PLANNING COMMISSION
DATE: 8/25/14
AGENDA ITEM: 4A – PUBLIC HEARING
CASE # 2014-41

ITEM: Savona 2nd Addition Residential Subdivision – Final Plat

Re: Savona 2nd Addition
Final Plat – Engineering Review

0000565.02SPF01a.dwg
Final Site Plan -
Townhome Area

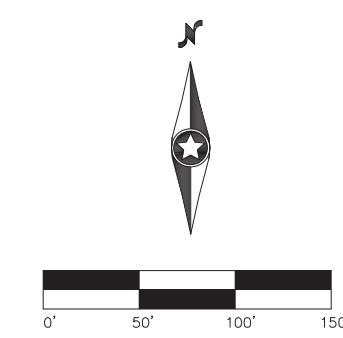
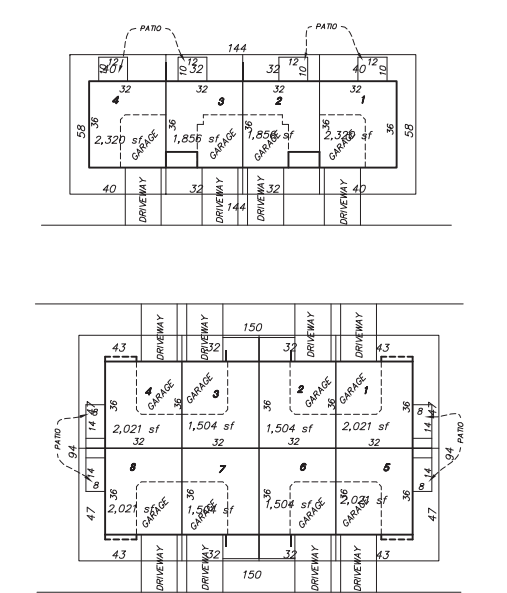
- The Grading, Drainage and Erosion Control Plan for Savona Multi-family area, dated 08.08.2014 must be incorporated into the Final Construction Plan set.
- The existing trunk watermain along Keats Avenue is not shown on this plan. Please update the Grading, Drainage and Erosion Control Plan for Savona Multi-family area to include all existing utility information to ensure the proposed storm sewer pipe maintains 10 feet separation from the existing trunk watermain.
- Sheet 6 of the Grading, Drainage and Erosion Control Plans must be updated with the expanded pond area for Outlot J.
- Temporary drainage and erosion control measures must be provided at the north end of James Avenue, a low point of the road in the temporary dead end condition.

- A cross walk and stop bar must be placed at the intersection of 5th Street North and 5th Street Lane.
- The Townhome area streets are proposed at 24 feet B-B. At this width these streets must be signed “No Parking” along one side of the street. Please add “No Parking” signs accordingly.

- Proper road width to allow access of fire apparatus. Would like more detail on the "PRIVATE DRIVES".
- Proper placement and adequate number of fire hydrants.
- Fire Sprinklers as required per code.
